SUBJECT: CERTIFIED MINUTES OF THE MEETING OF THE FUKUSHIMA
SUBCOMMITTEE ON APRIL 22, 2016

ADVISORY COMMITTEE ON REACTOR SAFEGUARDS
MINUTES OF THE FUKUSHIMA SUBCOMMITTEE MEETING
APRIL 22, 2016

The purpose of the meeting was to review interim staff guidance for focused evaluations and integrated assessment of reevaluated flooding hazards. The interim staff guidance conditionally endorses NEI 16-05, "External Flooding Assessment Guidelines." The meeting transcripts are attached and contain an accurate description of the matters discussed during the meeting. The presentation slides and handouts used during the meeting are attached to these transcripts.

FE Path 2: Effective Protection

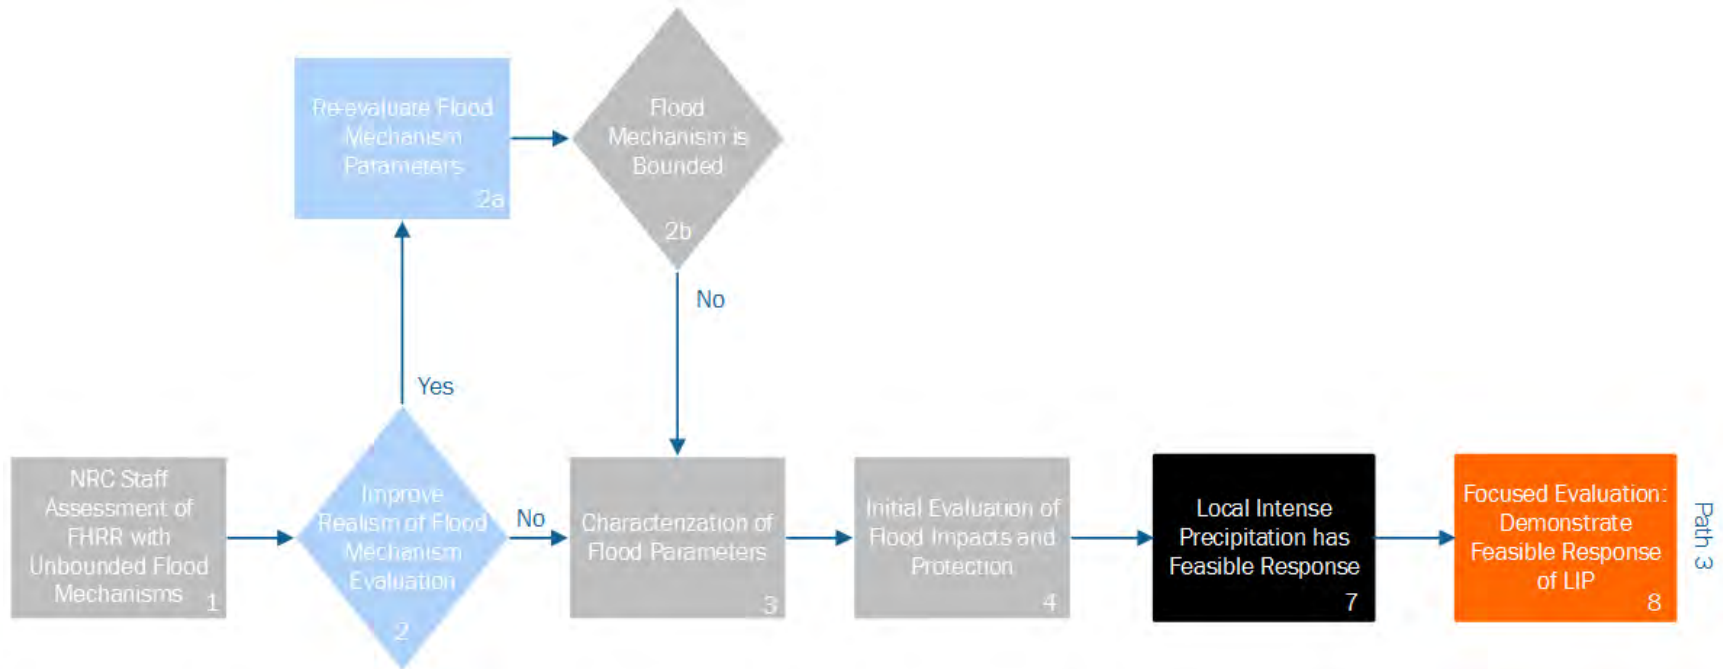
1 MEMBER SKILLMAN: Tom, how do you, not
2 you, how does this process account for uncertainty?
3 Identifying how much margin you have presumes that
4 you know if you will the acre-feet of water, the
5 location of your component, how high the component
6 is relative to other components. So my question is
7 how do you account for uncertainty in this riddle.

12 CHAIR STETKAR: Now can we ask the
13 questions? Your first bullet say ADemonstrate
14 available physical margin is adequate.@ You heard
15 him. His question is still on the table. I'll
16 point you to things in Appendix B that says certain
17 flood features may not lend themselves to specific
18 quantitative value but may need to be supported by
19 qualitative analysis. Things that say, ANegligible
20 or zero available physical margin can be justified
21 as acceptable if the use of conservative input
22 assumptions and/or methods in the flood hazard
23 reevaluation can be established.@

15 The idea there is that we are
16 addressing uncertainties what can be established as
17 overly conservative, unrealistically conservative,
18 inputs or methods or assumptions. So maybe an
19 example might be helpful. If you assume 50 dams in
20 a watershed fail at the same time and are
21 artificially located just upstream from the plant.

10 MR. BELLINI: If I add one more thing.
11 We talked about the one negligible margin crediting
12 conservatism, but there are suggestions in here
13 about how to quantify uncertainties, modeling
14 natural uncertainties, and so forth. So that's
15 still part of what we're saying. If you don't have
16 those excess conservatisms, then you will have to
17 possibly quantify your uncertainties to demonstrate
18 adequacy in your margin.

FE Path 3: Feasible Response to LIP

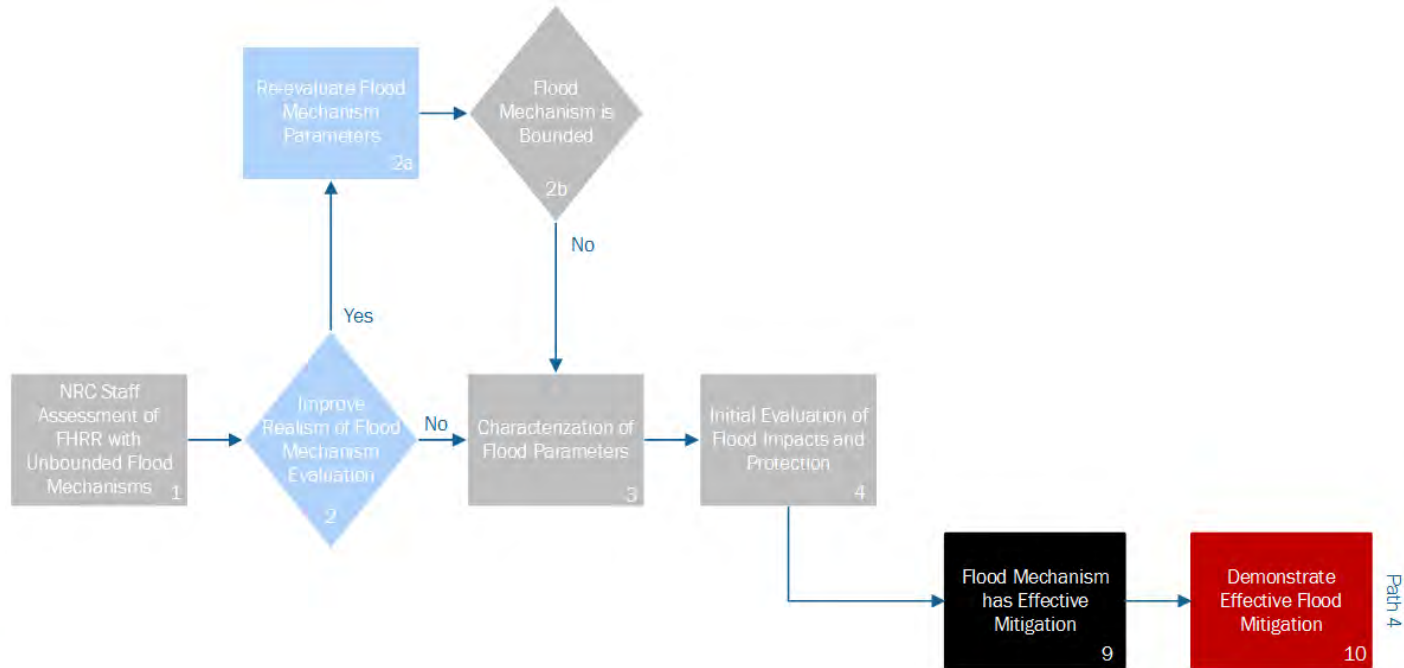
20 CHAIR STETKAR: Now my question is in
21 this construct now -- it's now 2016 -- and we had
22 different paths and different ways of dealing with
23 these things, why can't I do what smells like a
24 path two assessment for local intense precipitation
25 or a path four assessment for that matter if I need

17 CHAIR STETKAR: So this is simply a
18 trick to say I'm not never going to look from a
19 regulatory perspective at mitigation of local
20 intense precipitation. Is that correct?

12 Or if indeed you can't provide adequate
13 protection, you need some sort of mitigation
14 because you're going to get some damage. It's
15 called local intense precipitation, but
16 reevaluating that path forward. I don't understand
17 why local intense precipitation must of necessity
18 be treated differently other than the fact that
19 you're trying to argue that mitigation of local
20 intense precipitation will never be examined in the
21 Phase II regulatory assessments. And that's the
22 only thing that I can see of why path three exists
23 because it has been somehow negotiated.

14 MR. SHAMS: You could have a path two
15 assessment for local intense precipitation if you
16 have plant protection that's able to withstand that
17 hazard, yes. That would be equivalent. You still
18 call it a three, but nonetheless you're
19 demonstrating that the plant protection are able to
20 withstand that hazard.

19 MR. KENNY: This is Joe Kenny from
20 Research. Getting back to your original question,
21 fundamentally there is no reason why you couldn't
22 handle local intense precipitation by one of the
23 other paths. But there are a couple key points
24 about local intense precipitation which lend it to
25 having its own path. And fundamentally though one

1 is the ability to forecast a LIP event which is not
2 nearly as well developed as our ability to forecast
3 other large scale flooding events and (2) also the
4 impact, the duration, of that event on the plant is
5 going to be most of the time very, very short
6 compared to the other large scale flooding events
7 that we're concerned about.

IA Path 4: Effective Flood Mitigation

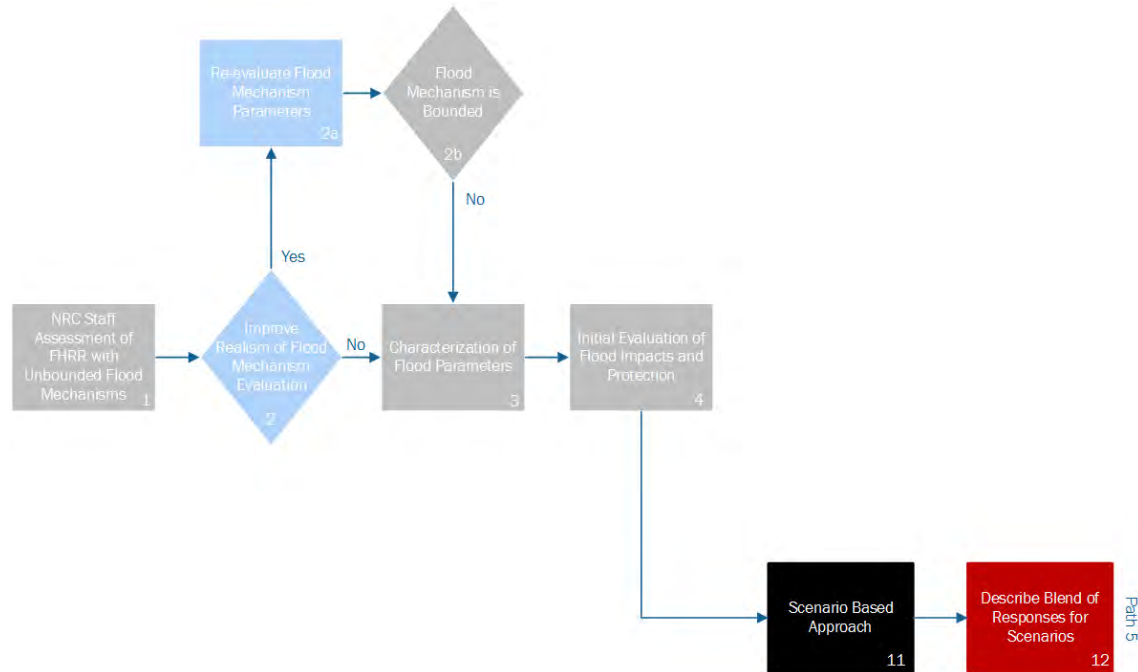
20 CHAIR STETKAR: But there is this --
21 You spoke this morning. In path four, it seems
22 that because they're deemed to be more frequent or
23 whatever the words are in the guidance there is the
24 onus to provide confidence that the mitigating
25 strategies are both feasible and reliable.

12 CHAIR STETKAR: A
13 Demonstrate overall
14 response is adequate.@ Now you're careful to use
15 words like effective flood mitigation applies for
16 path four while feasible mitigation applies for
17 path five. And I'm trying to understand what you
mean by that.

5 MR. ZACHARIAH: So path four is
6 demonstrating that the plant's response is adequate
7 without making any likelihood or frequency.

1 MR. TSCHLITZ: Feasible plus what we do
2 in Appendix C for effective flood mitigation for
3 path four is what we're saying is adequate, an
4 adequate overall site response. I don't know
5 whether we want to get into discussion of that now
6 or whether we want --
